## Industry/TSTF Standard Technical Specification Change Traveler

### Ice bed flow channel blockage surveillance requirement

**Attachment 2**  
**NUREG 1431, Revision 1**  
**Technical Specification 3.6.15**  
**Marked Up Pages**

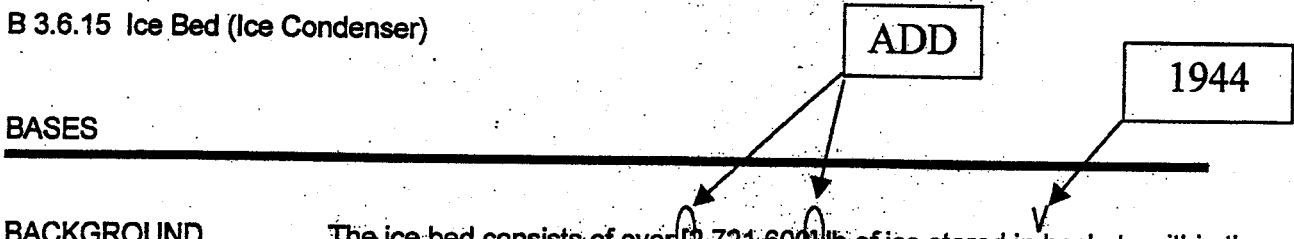
This SR ensures that the flow channels through the ice bed have not accumulated ice blockage that exceeds 15 percent of the total flow area through the ice bed region. The allowable 15 percent buildup of ice is based on the analysis of the sub-compartment response to a design basis LOCA with partial blockage of the ice condenser flow channels. The analysis did not perform detailed flow area modeling, but lumped the ice condenser bays into six sections ranging from 2.75 bays to 6.5 bays. Individual bays are acceptable with greater than 15 percent blockage, as long as 15 percent blockage is not exceeded for any analysis section.

To provide a 95 percent confidence that flow blockage does not exceed the allowed 15 percent, the visual inspection must be made for at least 54 (33 percent) of the 162 flow channels per ice condenser bay. The visual inspection of the ice bed flow channels is to inspect the flow area, by looking down from the top of the ice bed, and where view is achievable up from the bottom of the ice bed. Flow channels to be inspected are determined by random sample. As the most restrictive ice bed flow passage is found at a lattice frame elevation, the 15 percent blockage criteria only applies to "flow channels" that comprise the area:

Due to a significantly larger flow area in the regions of the upper deck grating and the lower inlet plenum support structures and turning vanes, a gross buildup of ice on these structures would be required to degrade air and steam flow. Therefore, these structures are excluded as part of a flow channel for application of the 15 percent blockage criteria. Industry experience has shown that removal of ice from the excluded structures during the refueling outage is sufficient to ensure they remain operable throughout the operating cycle. Removal of any gross ice buildup on the excluded structures is performed following outage maintenance activities.

Operating experience has demonstrated that the ice bed is the region that is the most flow restrictive, due to the normal presence of ice accumulation on lattice frames and wall panels. The flow area through the ice basket support platform is not a more restrictive flow area because it is easily accessible from the lower plenum and is maintained clear of ice accumulation. There is no mechanistically credible method for ice to accumulate on the ice basket support platform during plant operation. Plant and industry experience has shown that the vertical flow area through the ice basket support platform remains clear of ice accumulation that could produce blockage. Normally only a glaze may develop or exist on the ice basket support platform which is not significant to blockage of flow area. Additionally, outage maintenance practices provide measures to clear the ice basket support platform following maintenance activities of any accumulation of ice that could block flow areas.

Frost buildup or loose ice is not to be considered as flow channel blockage, whereas attached ice is considered blockage of a flow channel. Frost is the solid form of water that is loosely adherent, and can be brushed off with the open hand.
